**ADDENDUM NO. 1
TO
PLANS AND SPECIFICATIONS
FOR
PROJECT NO. ENG200372291**

DESCRIPTION OF PROJECT: Double Vault Toilet Installation Improvements 2021

LOCATION: Brown County State Park

INDIANA STATE AGENCY: DEPARTMENT OF NATURAL RESOURCES

Site # 14 - Hesitation Point

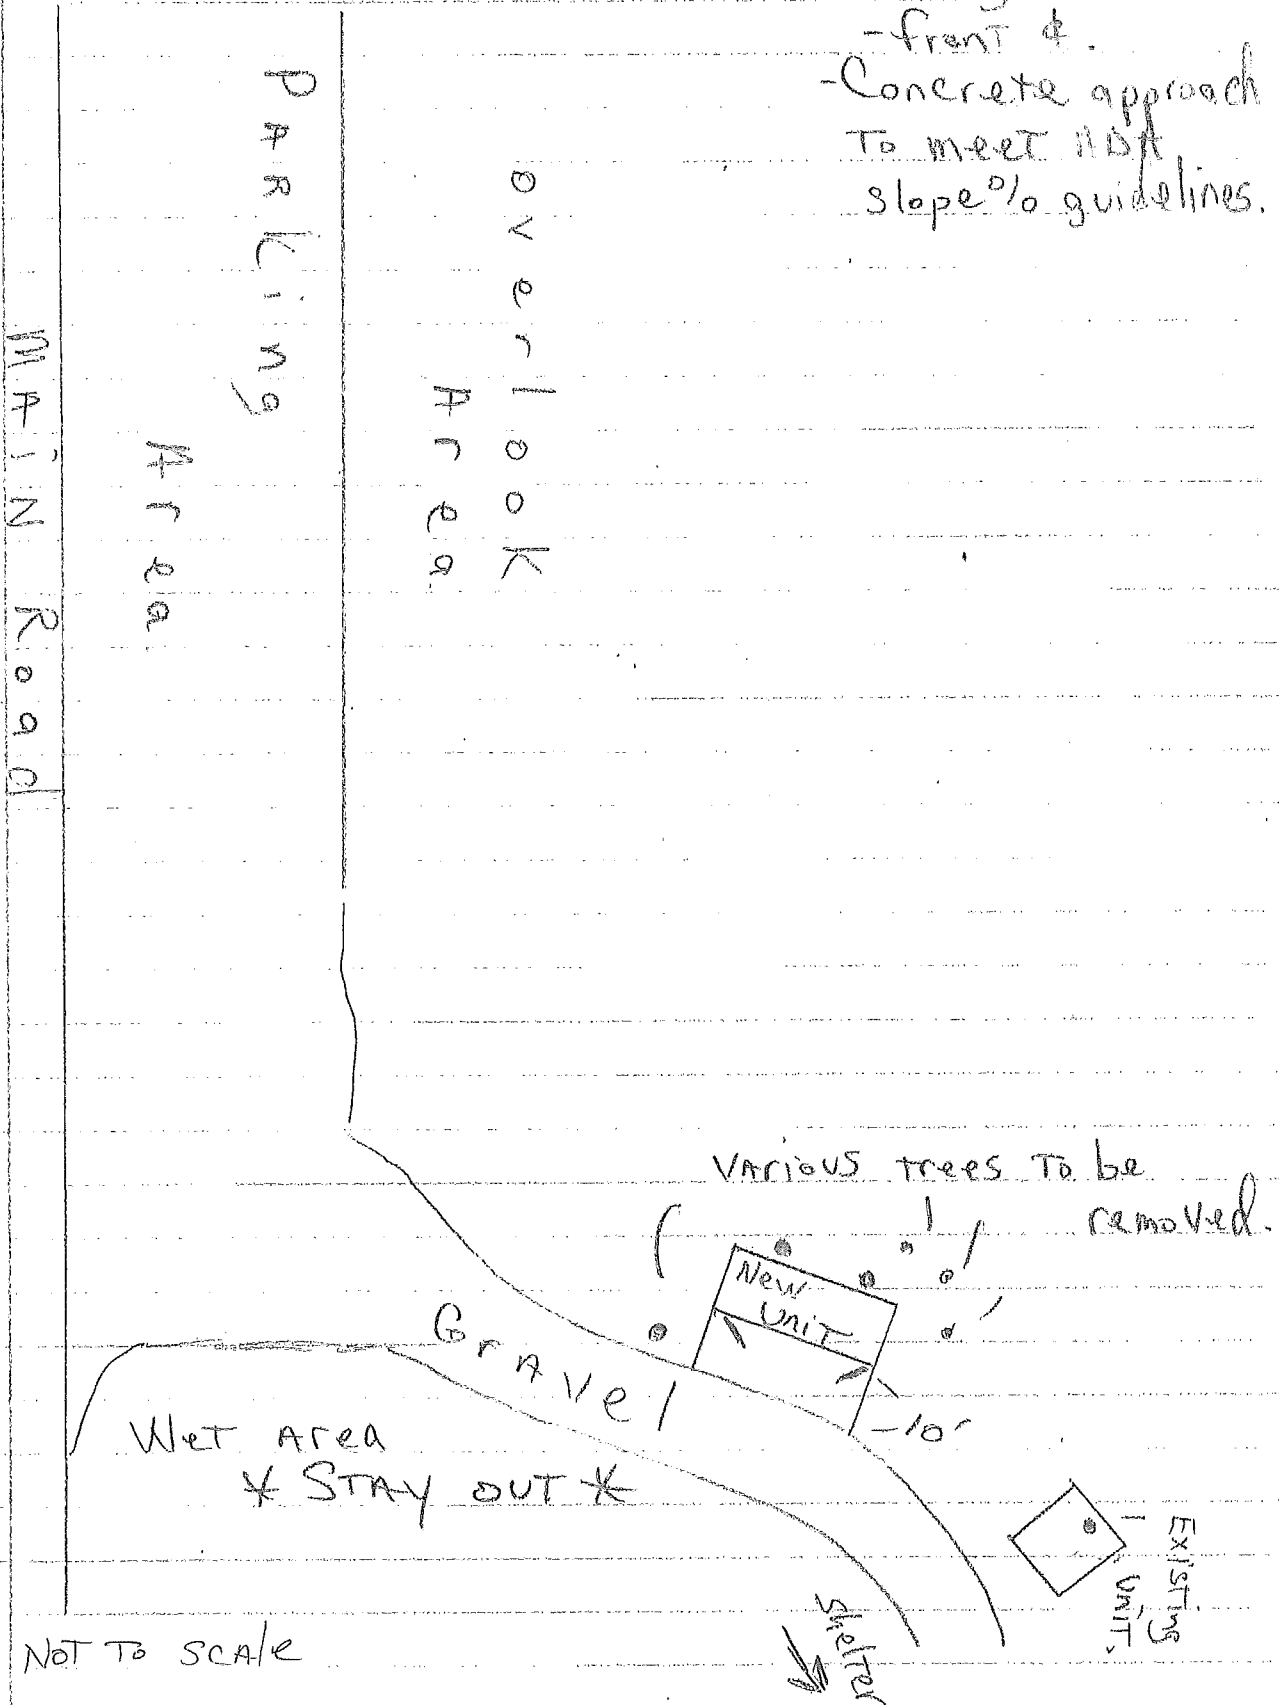
- Demo old unit
- grass finish grade
- Finish Floor 3" above gravel surface - front &
- Concrete approach to meet ADA Slope % guidelines.

- Final location to be discussed @ pre-const.

Site # 15 - Lower Shelter

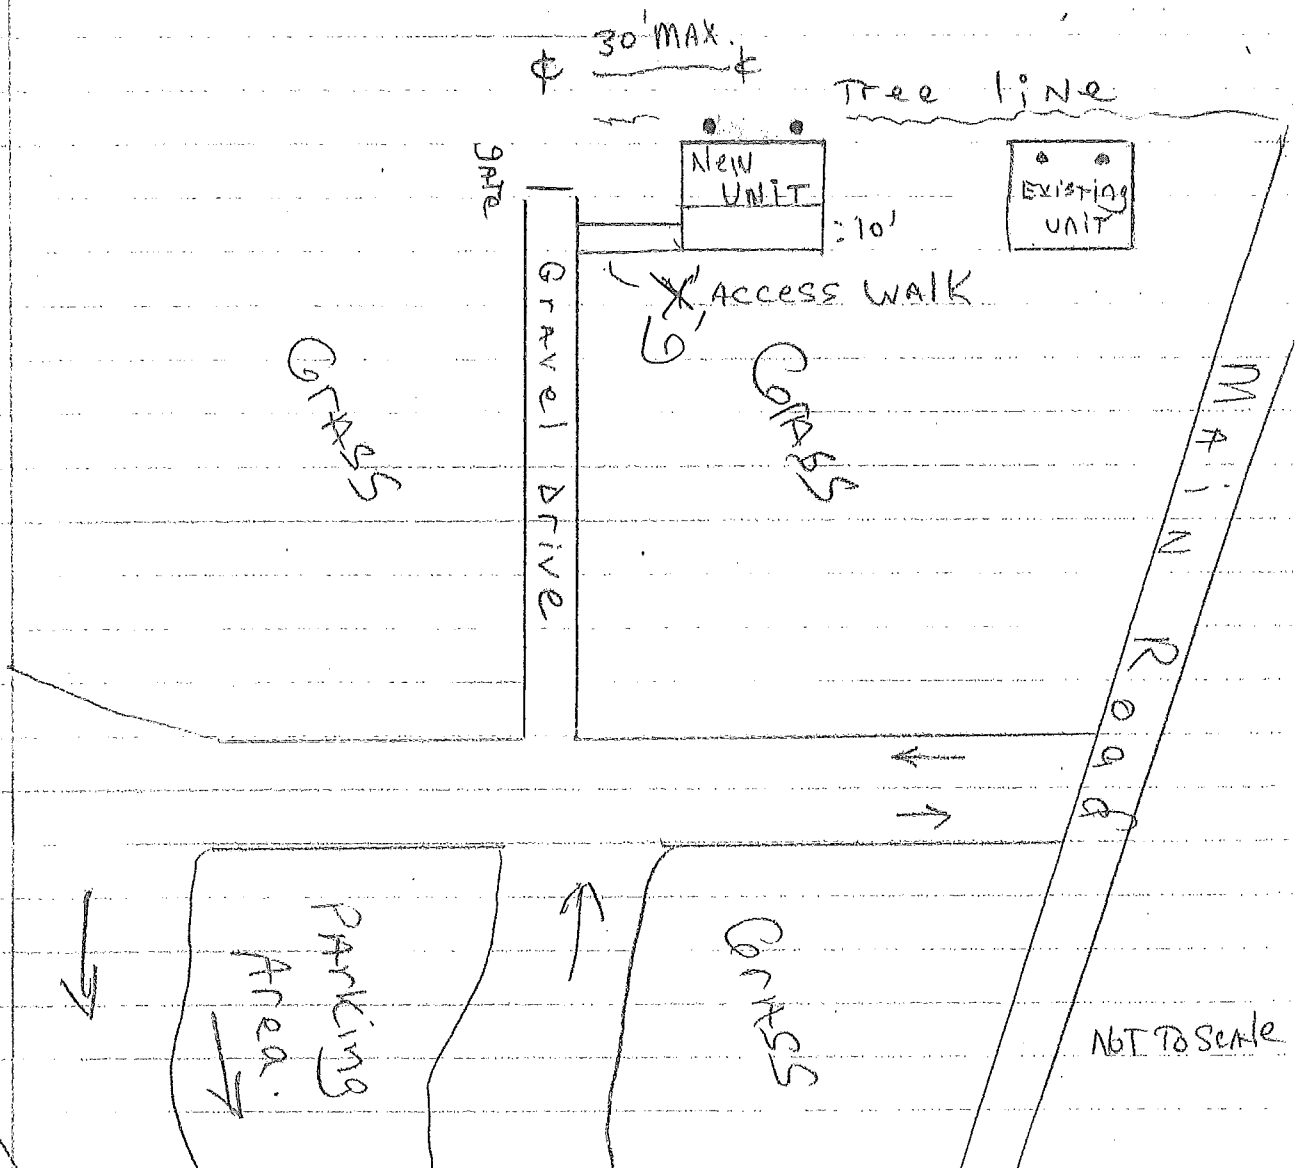
- COPS. - 39,190 X 86,215
- Demo old unit.
- grass finish grade
- * - Finish Floor TBD at time of excavation.
- * - EXACT location TBD before excavation.
- Concrete approach to meet ADA slope % guidelines
- * Access to the unit to meet ADA slope % guidelines.

North
 CATARAC Falls - 39.43 x -26.17

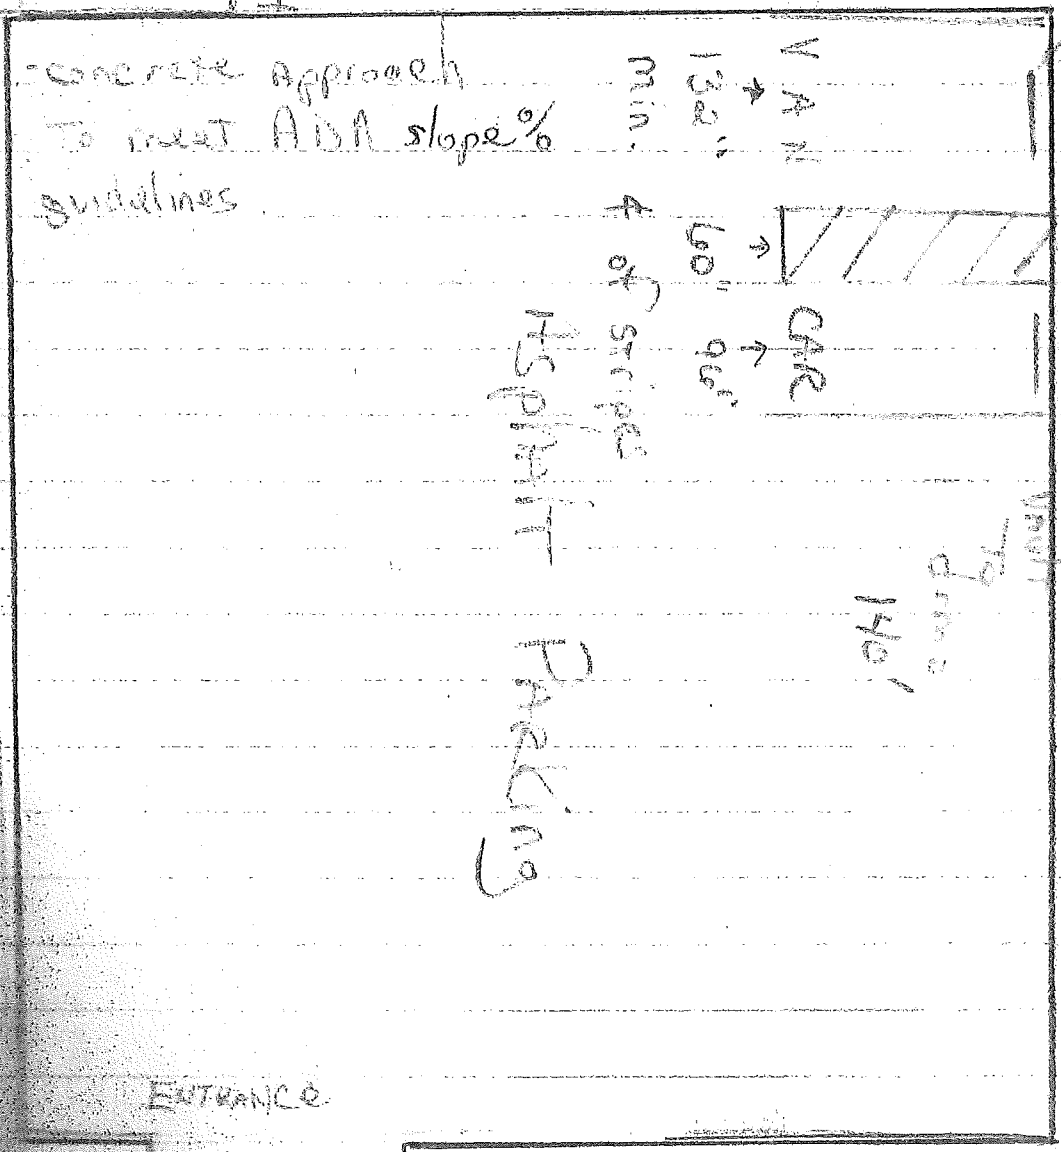
- NW corner of parking area.

- grass seed finish grade.
- Finished Floor 3" above existing asphalt - ϕ
